August 10, 2023

Version 3

Product Update: 2022 CR-V EPS Gearbox ReplacementSupersedes 22-011, dated March 3, 2023, to revise the information highlighted in **yellow**.**AFFECTED VEHICLES**

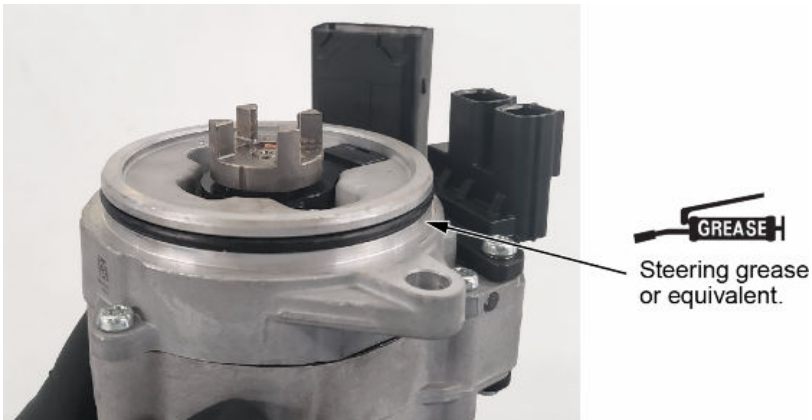
23. Install the EPS motor/control unit onto the new P/S gearbox using the new replacement parts included in the kit:

NOTE: The motor bushing and rubber bushing are greased and installed in the new gearbox.

- 23.1. Apply steering grease or equivalent on the new O-ring and install it onto the EPS motor/control unit.

EPS MOTOR CONTROL UNIT
Turn unit two or three times to the right and left (about 45 degrees).

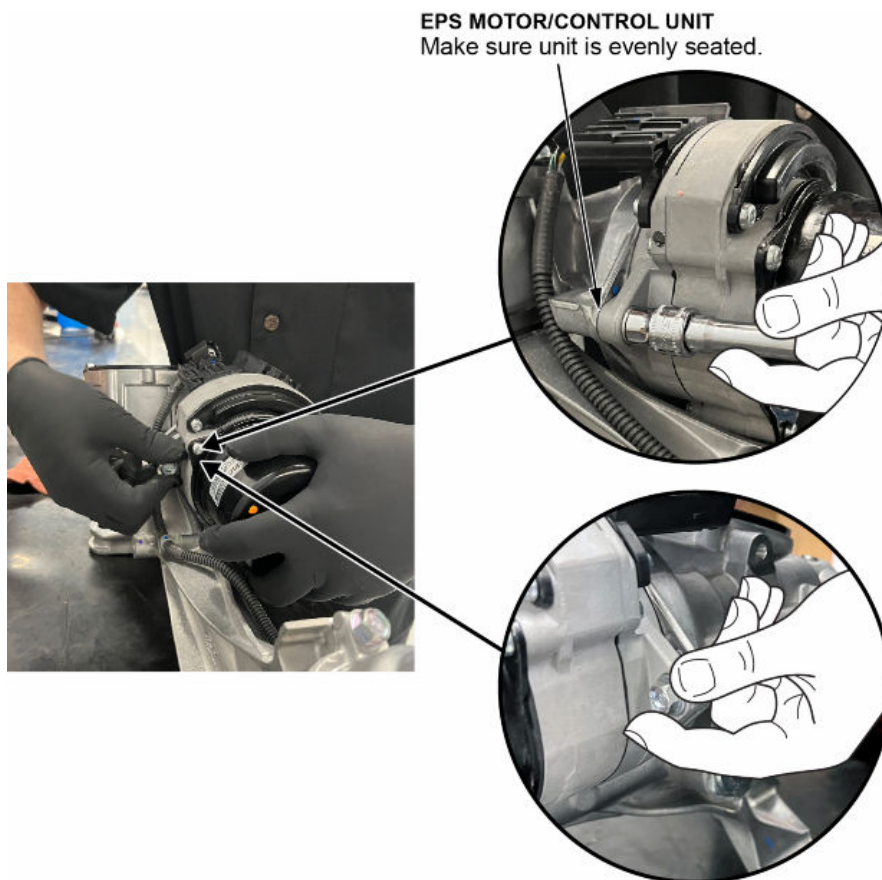
- 23.3. Turn the EPS motor/control unit two or three times to the right and left about 45 degrees.

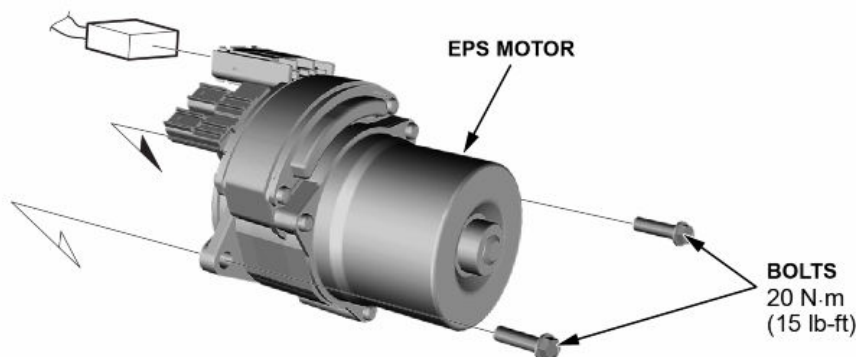
23.4. Loosely install the new EPS motor/control unit mounting bolts by hand but do not tighten.

- To prevent damaging the motor and/or gearbox, DO NOT use power tools to install or tighten the bolts.
- Make sure the EPS motor/control unit is evenly seated on the P/S Gearbox.

23.5. Tighten the EPS motor/control unit mounting bolts to 20 N·M (15 lb-ft).
